# PARTS & SERVICE NEWS

REF NO.	AT04013
DATE	Feb. 3, 2004
(C) Page 1 of 3

**SUBJECT:** MODIFICATION OF THE MUD GUARD FOR THE BODY ON HM300-1, HM350-1 AND HM400-1

**PURPOSE:** To introduce the modification of the mud guard for the body on HM300-1, HM350-1, and HM400-1.

Fig. 1

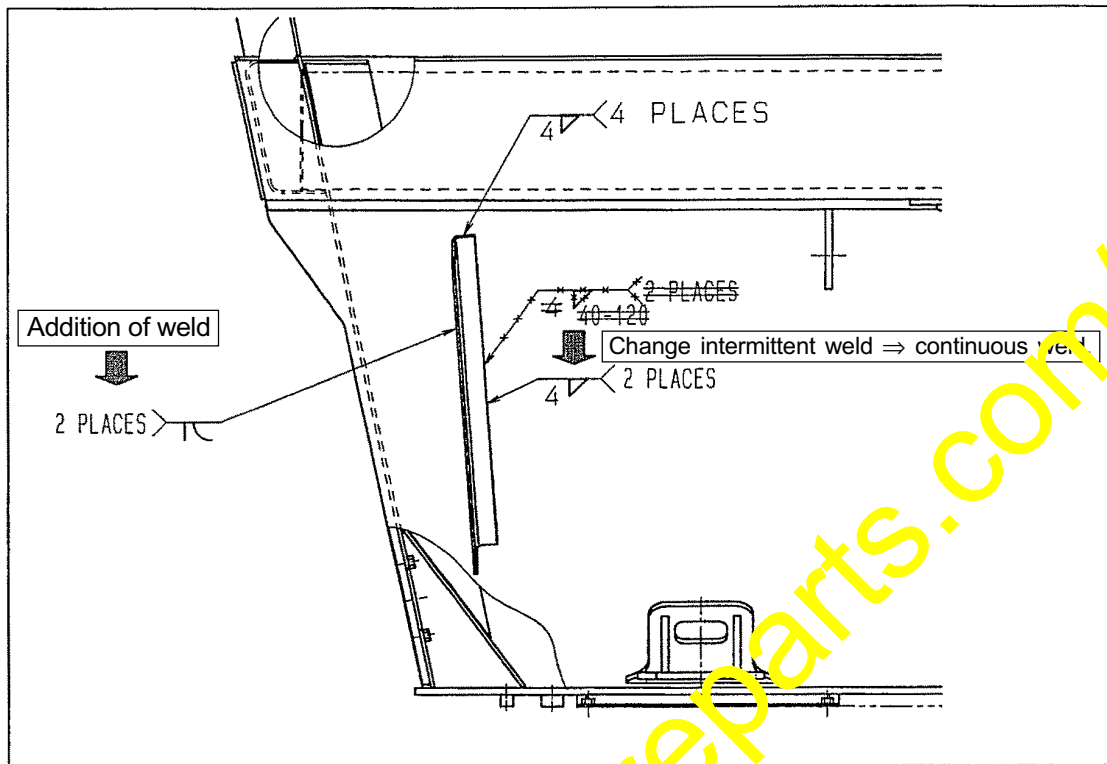
The bracket weld may be cracked by warp on the side plate of the body due to impact and earth pressure when loaded. In such a case, make a modification in the manner introduced by this Service News.

To prevent cracks in the bracket weld of the mud guard for the body, rigidity was improved by changing to full arc weld as shown below (See Fig.1).

- 3-1 Stop the vehicle on the flat ground, chock the wheels and stop the engine.
- 3-2 Remove the guard and plate to avoid damage during mending by weld (See Fig. 2).  
Care should be taken not to lose the parts removed, because they will be reused.
- 3-3 Remove the welded bracket and clear welding beads.
- 3-4 Mend by weld as shown in Fig. 1.
- 3-5 Install the guard and plate removed.

Fig. 3

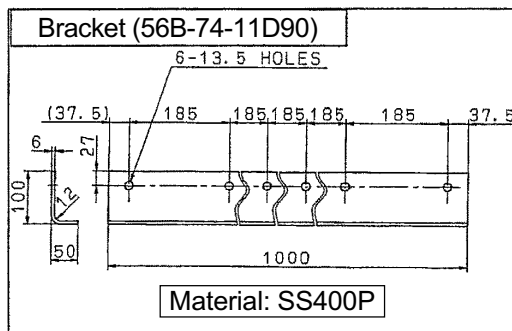
- 3-6 If the bracket is damaged and it cannot be reused, make the bracket with the shape as shown in Fig.3 and carry out weld according to Fig.1.  
(The bracket is common to HM300-1, HM350-1, and HM400-1.)

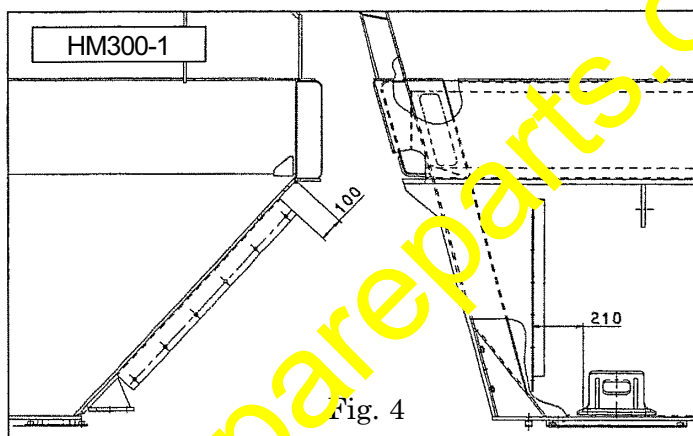
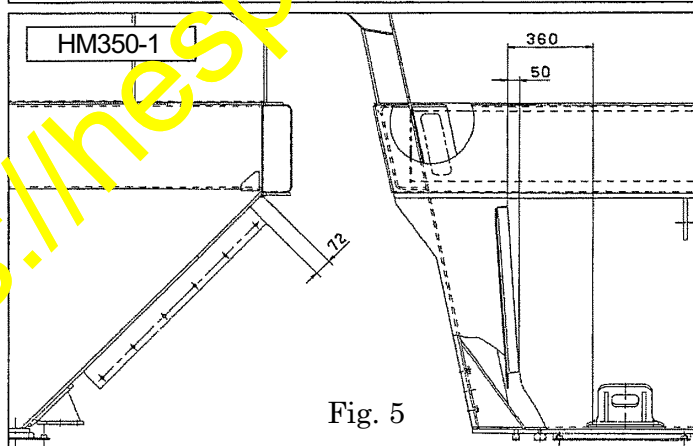
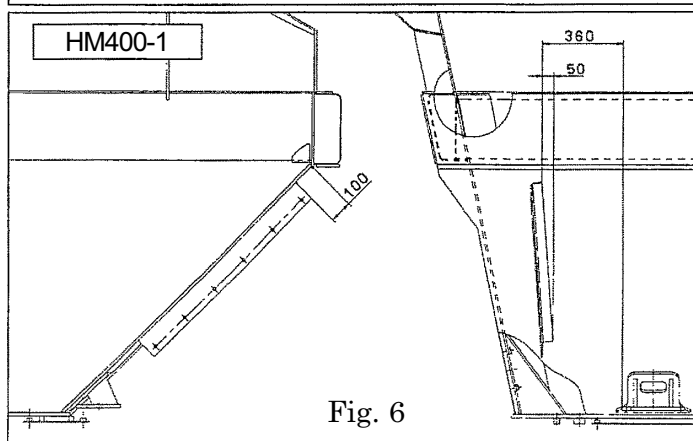
- 3-7. For installation dimensions of the bracket, conform to the following.
